Assessment of Dam Safety of Coal Combustion Surface Impoundments

Indianapolis Power & Light Company

Petersburg Generating Station

Draft Report

68. Pond A - Discharge, looking west at discharge canal to the White River.

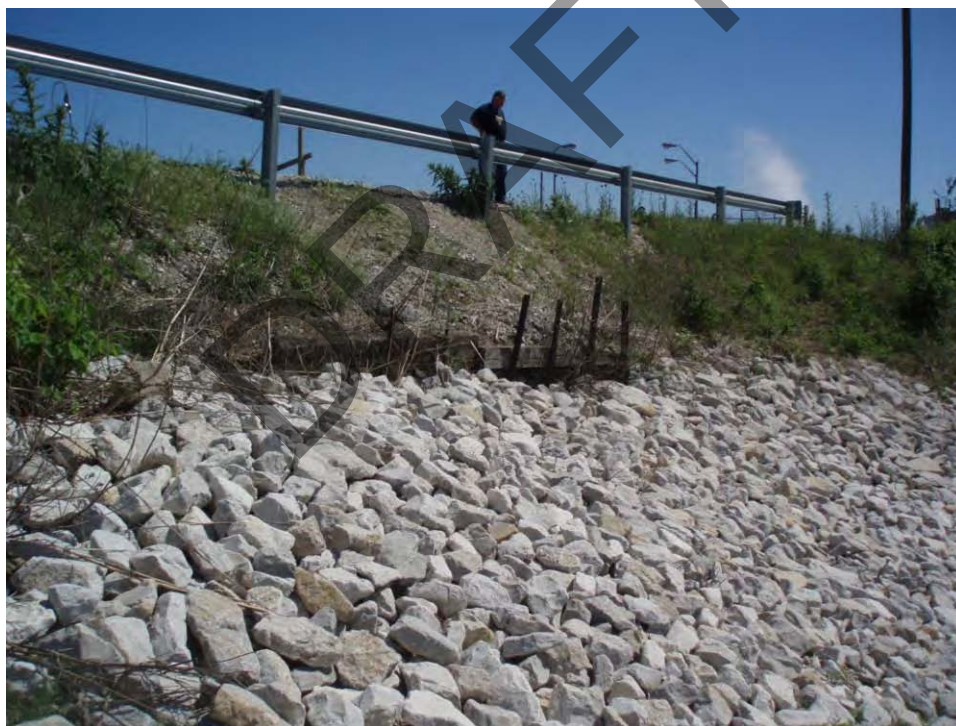
67. Pond B - South embankment crest, looking northeast.

71. Pond A - Discharge, overview of downstream area from outfall.

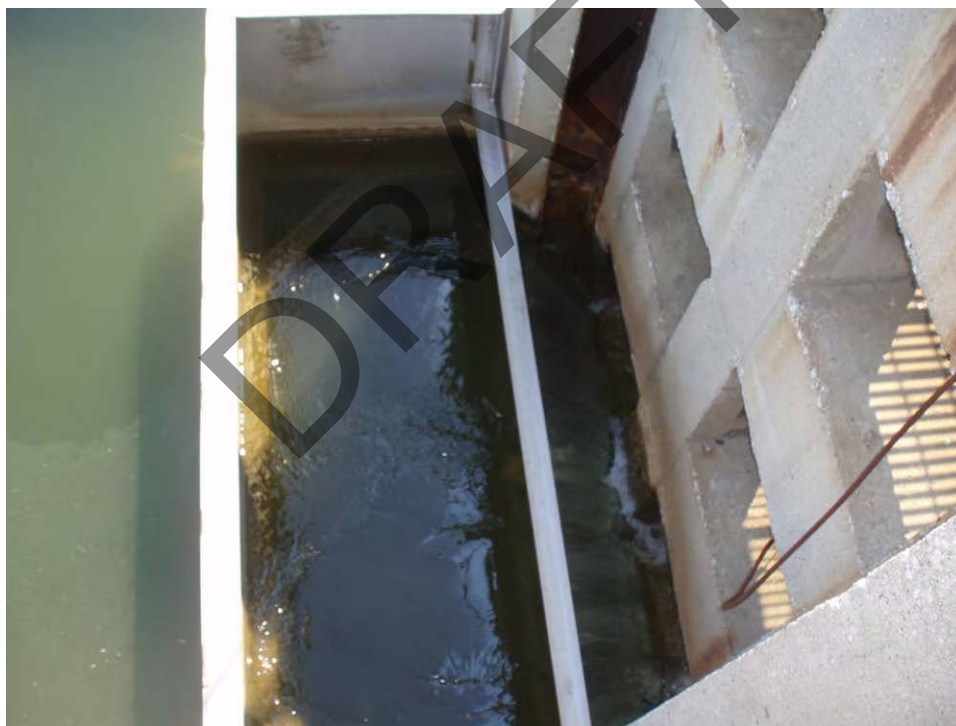
70. Pond A - Discharge, southwest embankment exterior slope looking at steep slope above outfall repaired recently with riprap.

128. Pond C -East embankment crest, looking southwest. Note tire rutting was observed in very soft stabilized FGD near the crest.

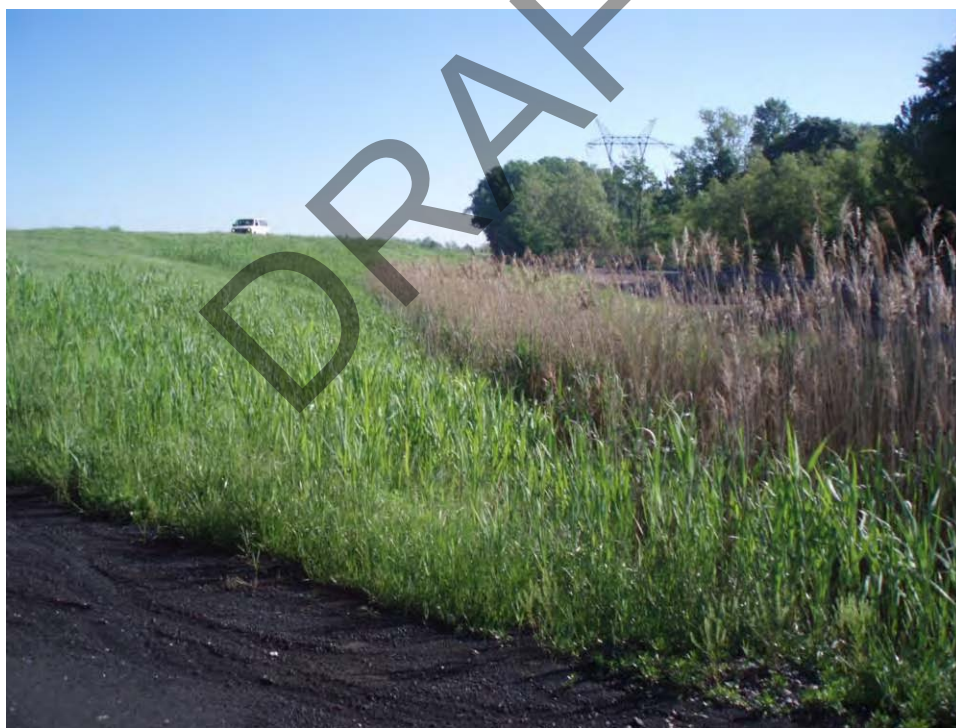
127. Pond C - East embankment exterior slope and drainage ditch, looking southwest. Note water level in drainage ditch approximately 1.5' below roadway and 5'-8' tall vegetation on lower portion of the slope extending from northern corner to access ramp. Slope at drainage ditch is over-steepened.
